**Town of Kittery
 Planning Board Meeting
 April 13, 2023**

ITEM 4 – 283 Route 1 Mixed Use Master Site Development Plan – Sketch Plan Review

Viewpoint Application #: SKPR-23-1

SKETCH COLOR SITE PLAN

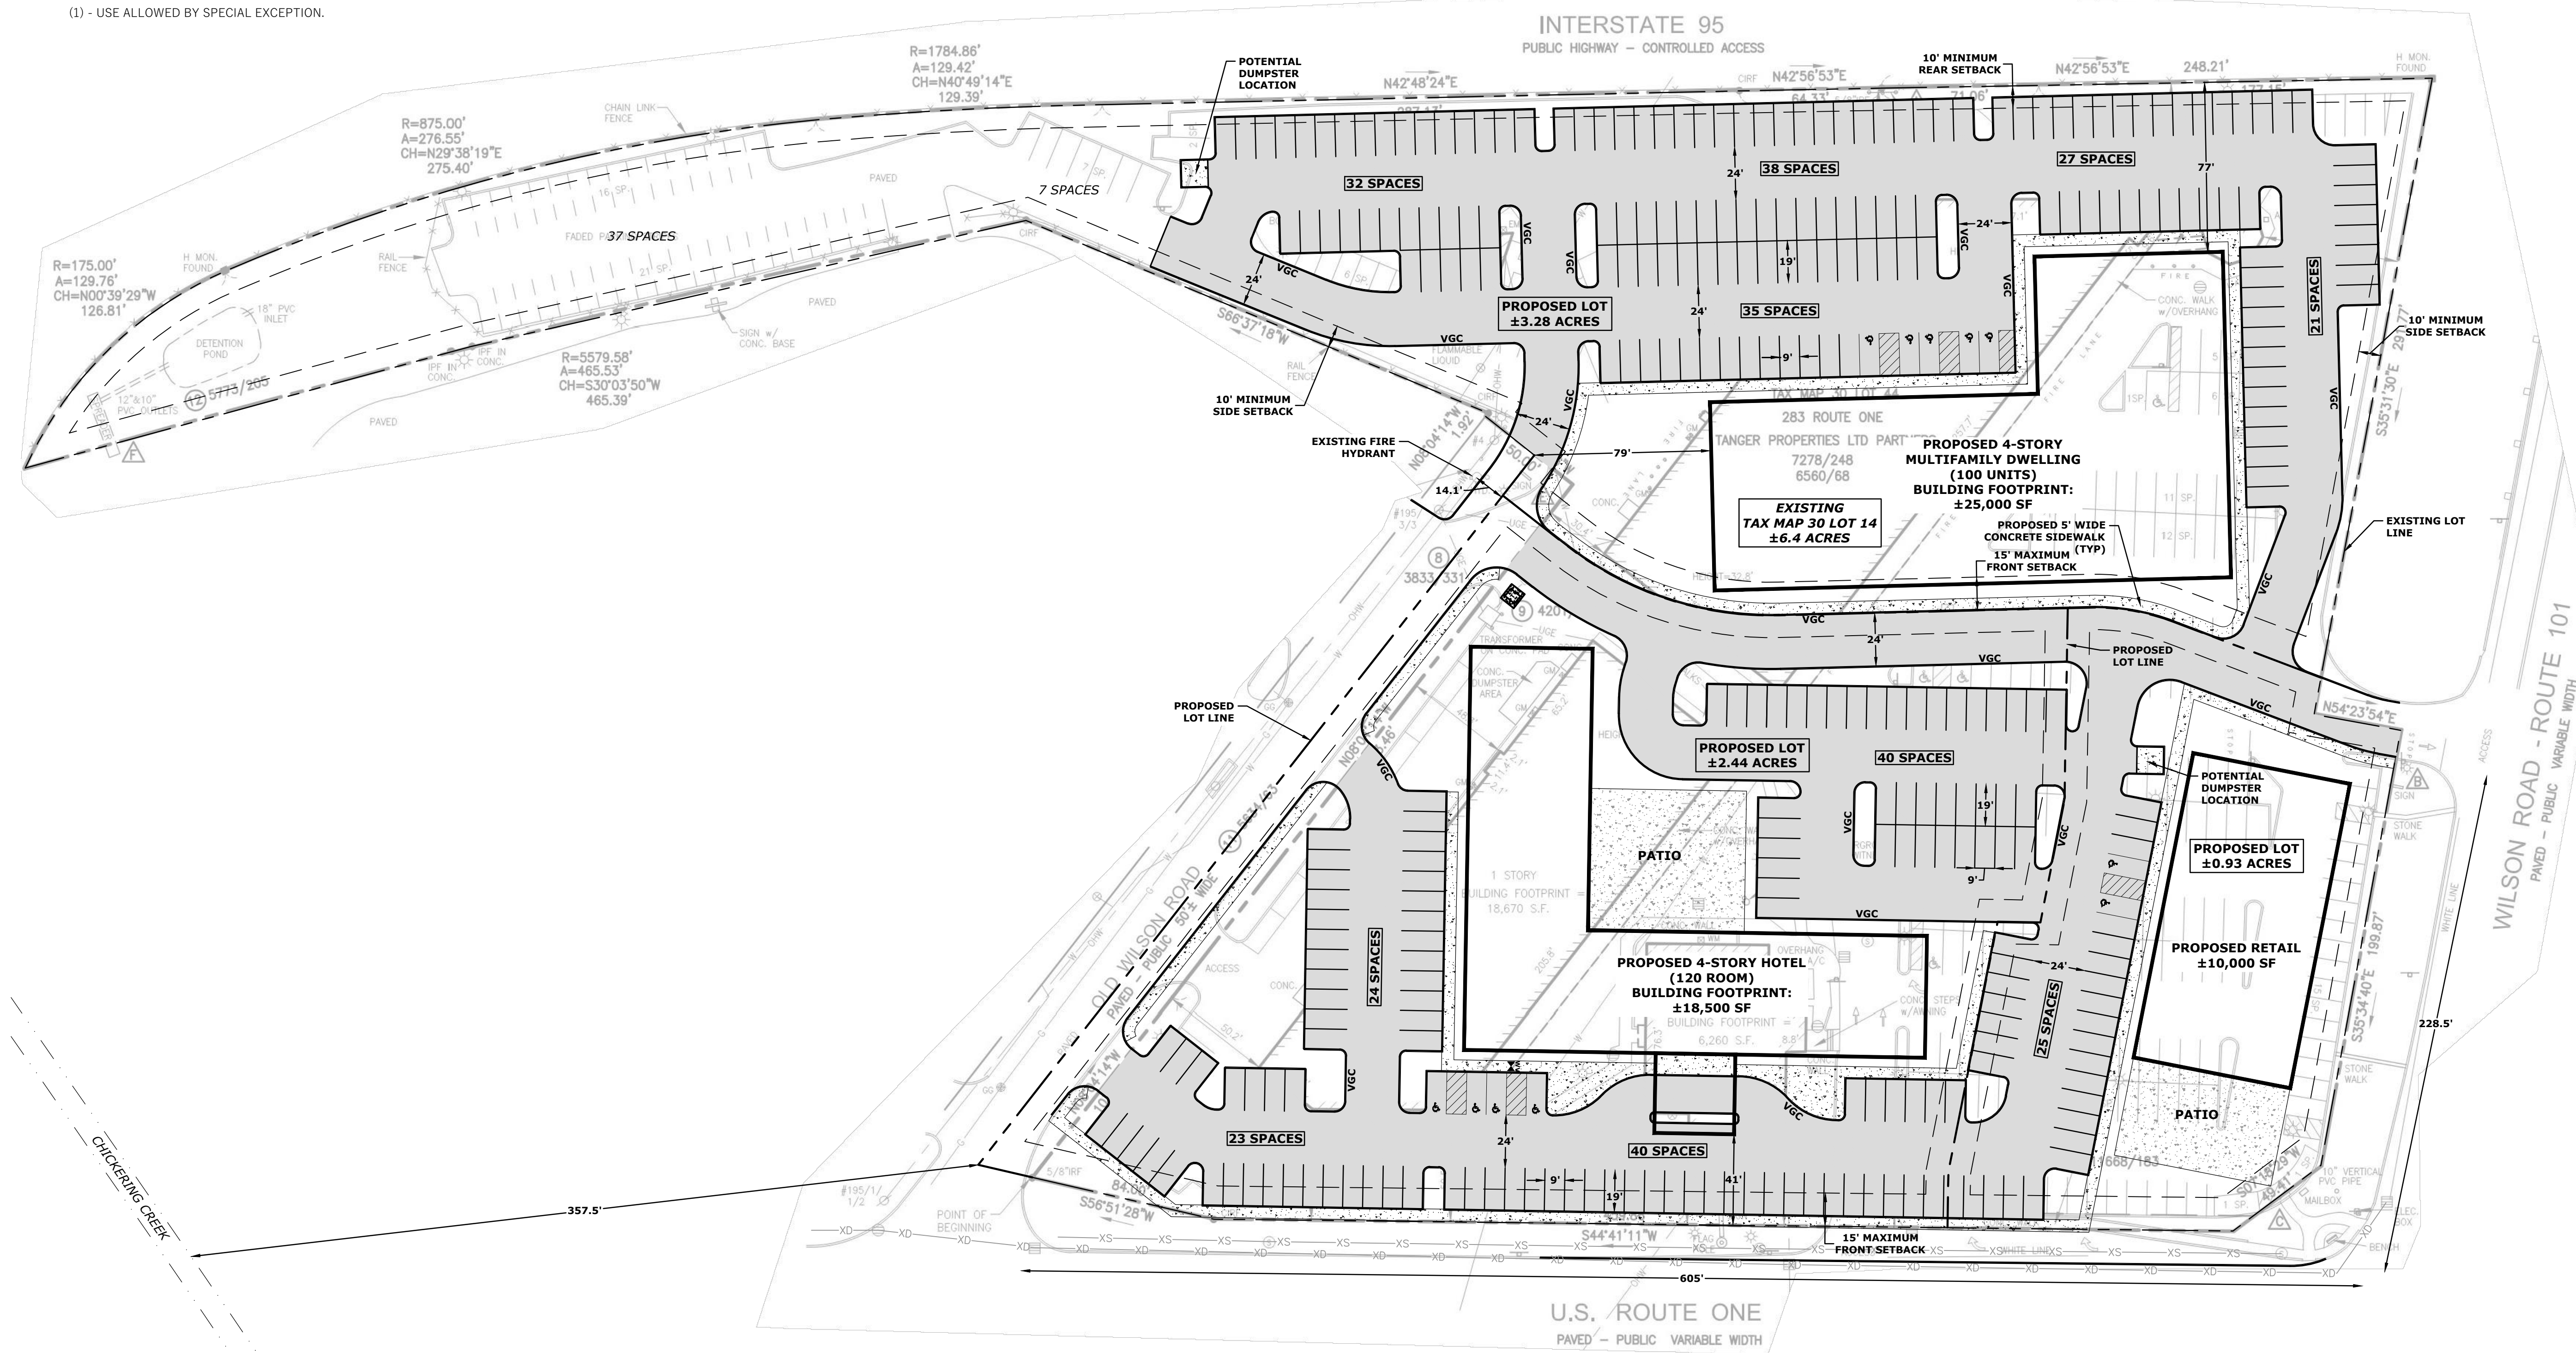
63 The definition of front yard in Title 16 indicates that the *maximum* building setback of 15 feet would
 64 apply to both street frontages. Should the buildings lie closer to the street/ sidewalks? Discussion with
 65 Fire dept. staff pending. Placing buildings closer to sidewalks is generally deemed safer and more
 66 attractive for pedestrians by visually encouraging motorists to reduce speeds, reducing crossings of
 67 driveways and parking areas, shortening distances between entries and sidewalks, and creating a more
 68 visually interesting walking environment. However, the applicant may present convincing rationale for
 69 board consideration of alternative design(s). Guidance should be provided during this or a subsequent
 70 meeting.

72 The current conceptual plan shows a sidewalk located in the interior of the site near the intersection of Rte
 73 1 and Wilson Rd. Is this preferred over a sidewalk along Wilson Rd? Are sidewalks desired along the
 74 entire Wilson Rd property frontage? Is Wilson Rd eastbound lane widening desirable to accommodate a
 75 bike lane or shoulder? Discussion with Public Works and Maine DoT (TMP) pending.

2.b Min street frontage	No minimum. See 16.5.14 Lots.	Yes	Frontage on two public streets. Not a flag lot or spaghetti lot.
2.c Max front setback	15 feet*	No	Prospective hotel does not comply. See discussion items.

3.d Traffic and circulation	Sidewalks and roadways required within site and to adjoining areas	Generally	Staff recommend provision of walkways connecting building entries to nearest sidewalk

3.e Open space	25% of property; landscaped	Generally	Amount ok; landscaping design pending
4.a.1 sidewalks	Required in RoW	TBD	Where to locate public sidewalk near street intersection?

4.a.2 connectivity	See 3.d.	TBD	Staff recommend pavement markings or surface variation to define walkways across driveway and parking areas

4.a.4 service areas	Fencing and screening required	TBD	
4.a.4 parking location	Behind residential buildings. *	No	Apartment building must shift closer to street to comply. See also 2.c max front setback
4.a.6 Lighting	Must comply with 16.7.11	TBD	Lighting plans and specifications to be provided during preliminary plan review
4.b.1 open space	15% of lot	Generally	4.b.1 (15%) conflicts with 3.e (25%)
4.c.1.a parking stalls	1 per dwelling unit	Yes	
4.c.3 joint use parking	allowed		
4.d Landscaping	Trees required	TBD	
4.e Buffers	required	TBD	See landscaping requirements

SKETCH SITE PLAN

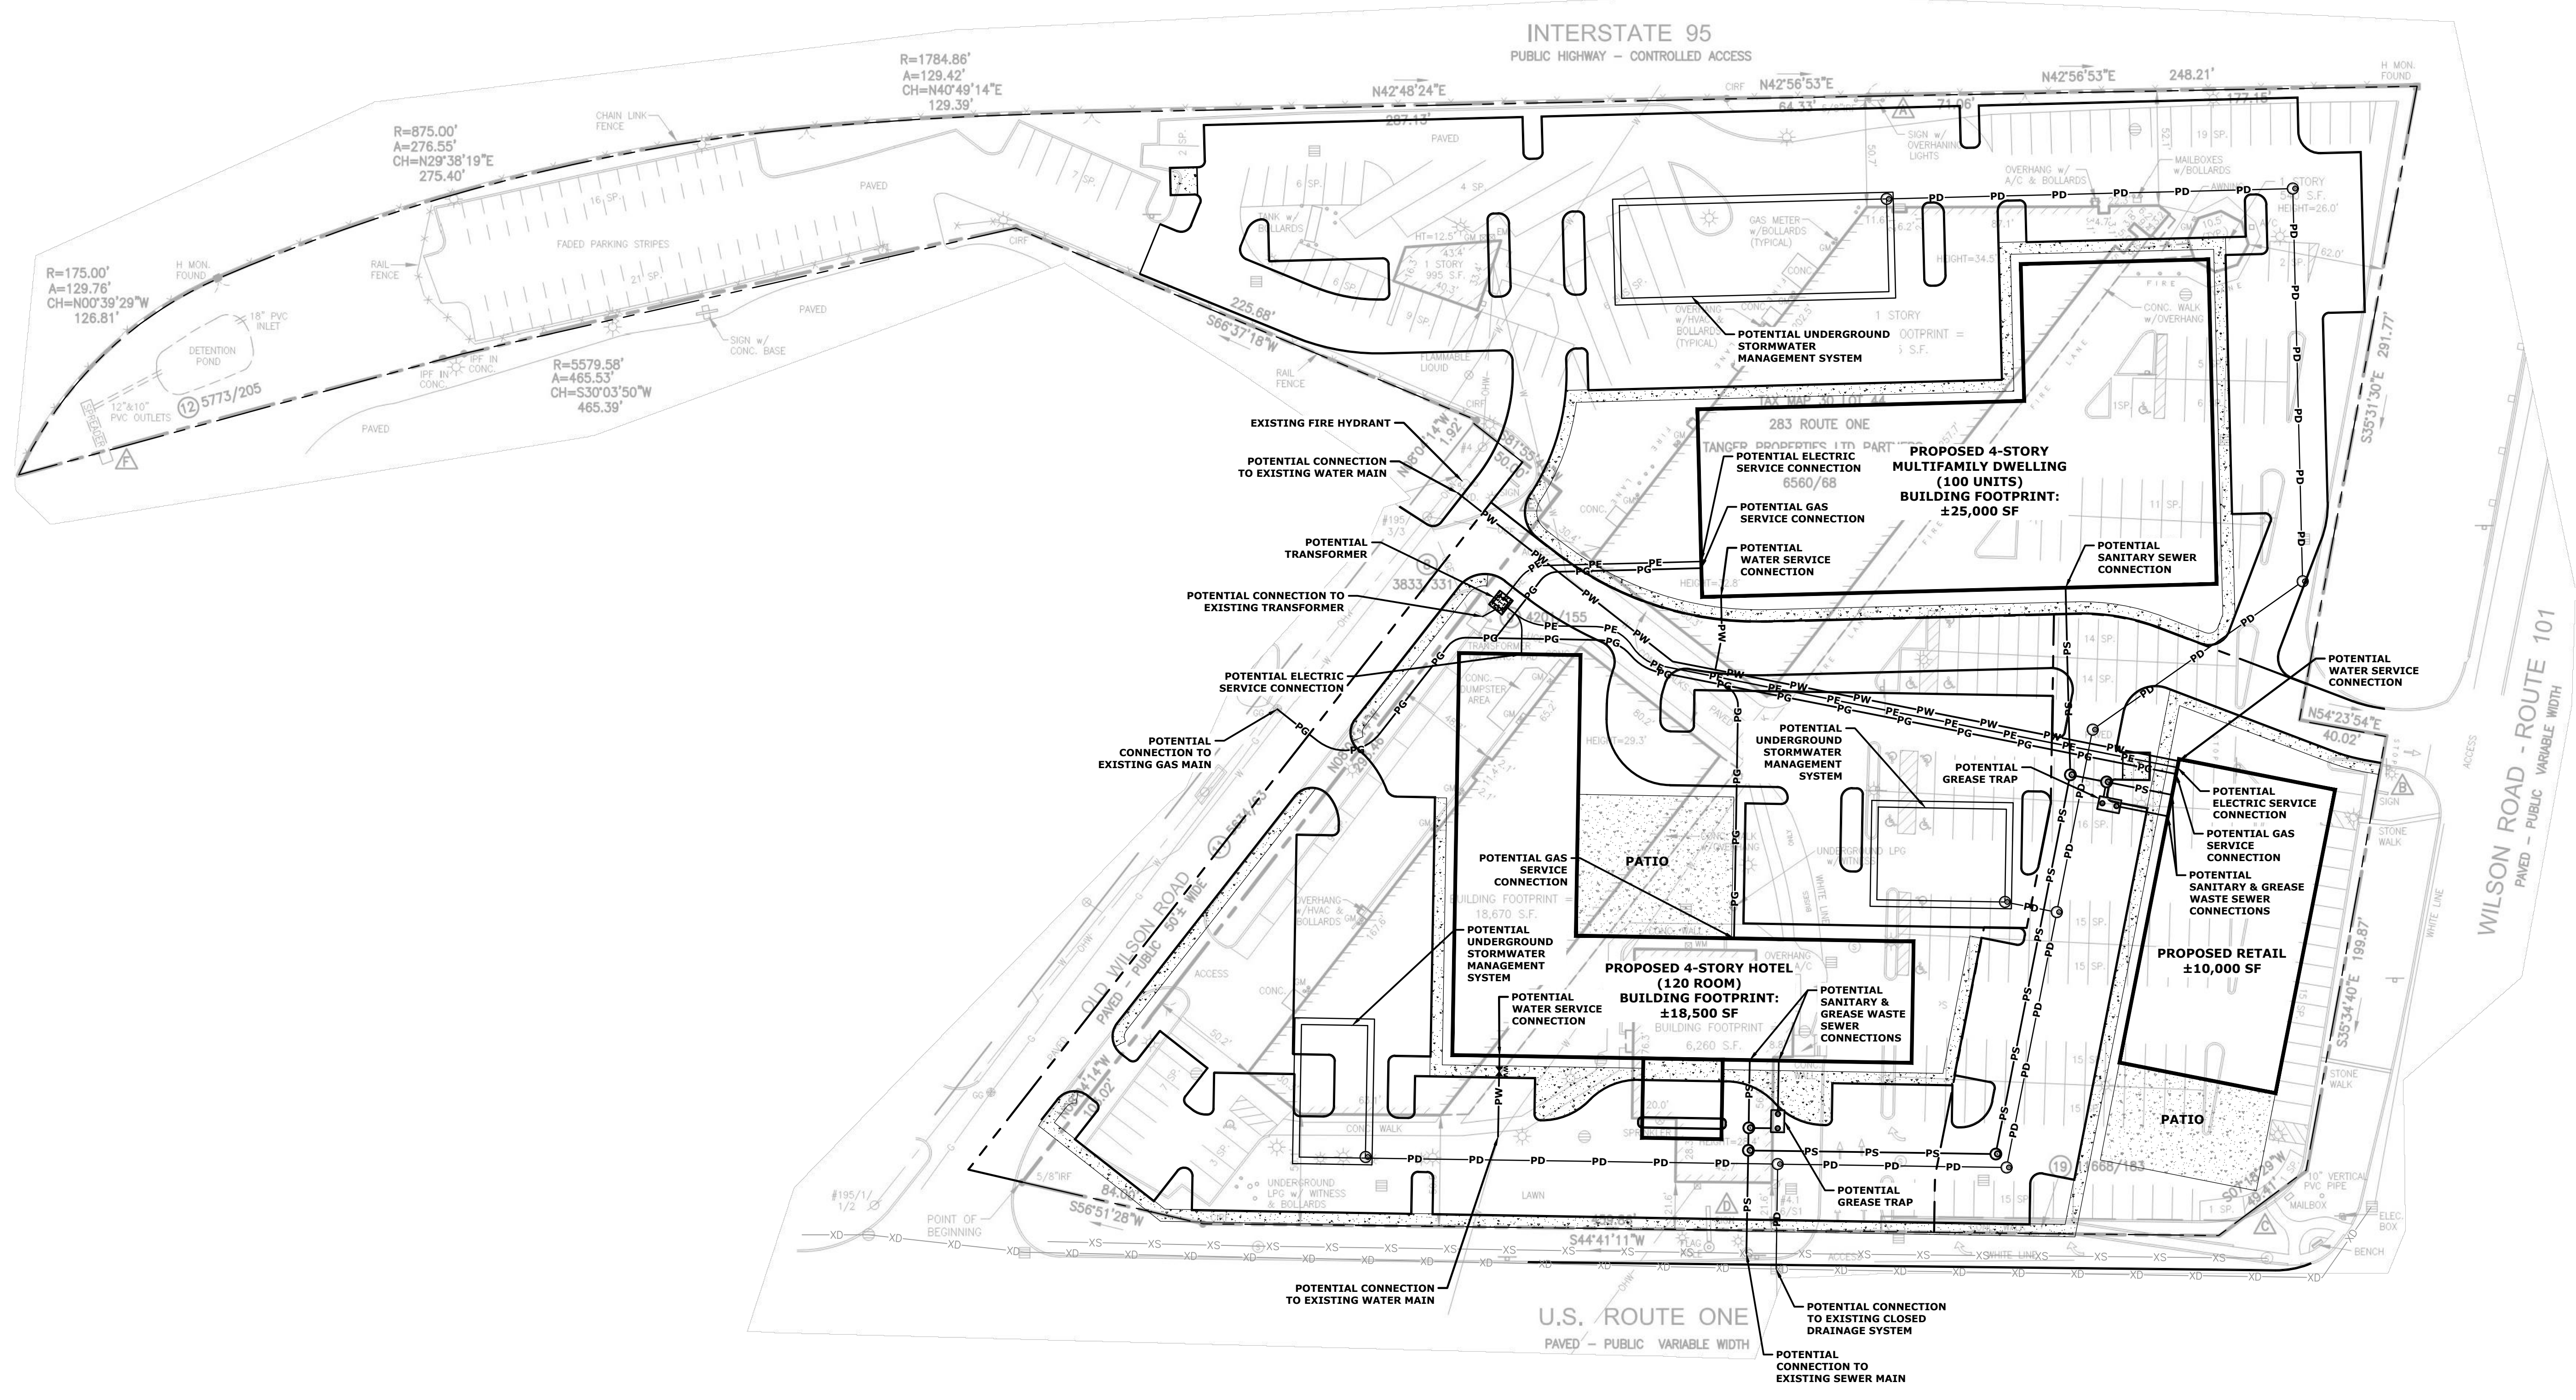
- 157 F. Parking and loading: conceptual plans appear to generally comply with drive aisle and parking stall
158 standards. Parking count could be reduced.

SKETCH DRAINAGE / UTILITIES PLAN

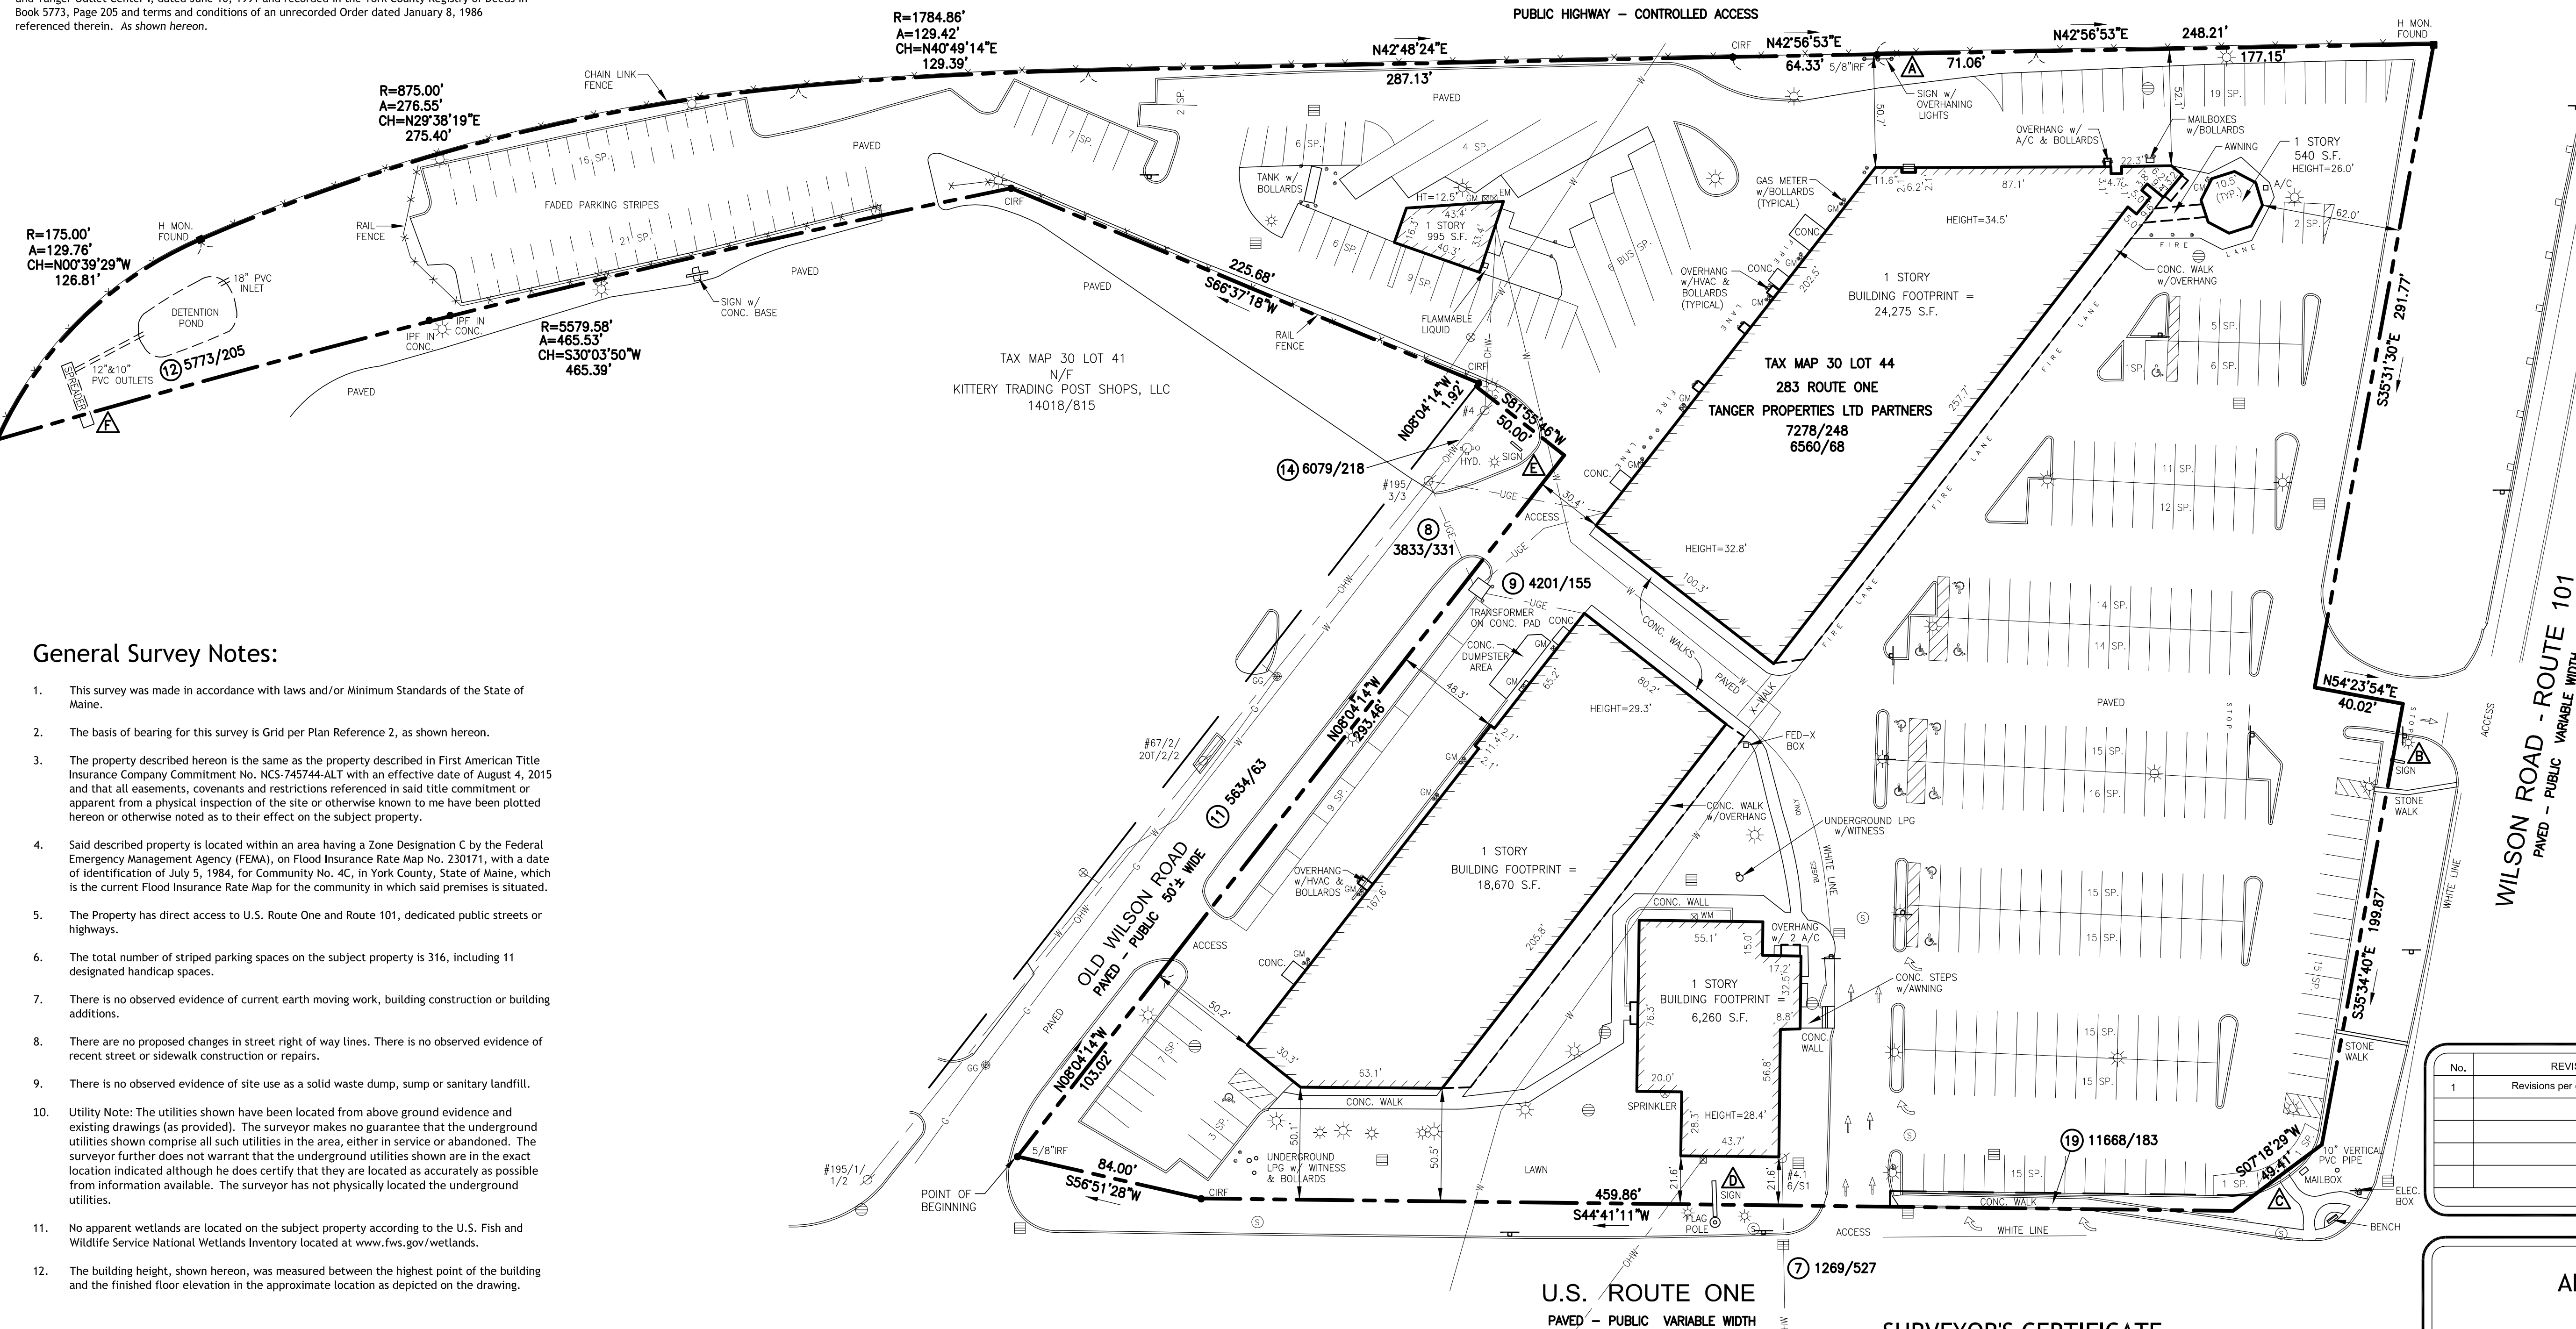
- 148 B. Sewer: utilities available. Must be designed to conform with standards. Local pump station or
149 transmission facilities may require upgrade. Connection fees = partial mitigation for impacts. Review
150 by Sewer Dept. pending.

- 151 C. Stormwater: Maine General Permit and peer review by consulting engineers required.
152 Redevelopment conditions should improve vs. existing.
- 153 D. Post-construction stormwater management: monitoring plan required by Town code & to be
154 reviewed by peer engineer. Must be approved during preliminary site plan review.

- 159 G. Utilities: must be underground. Conceptual utility plan provided.
- 160 H. Lighting: lighting specifications and photometric plan to be provided for peer review with
161 preliminary site plan.
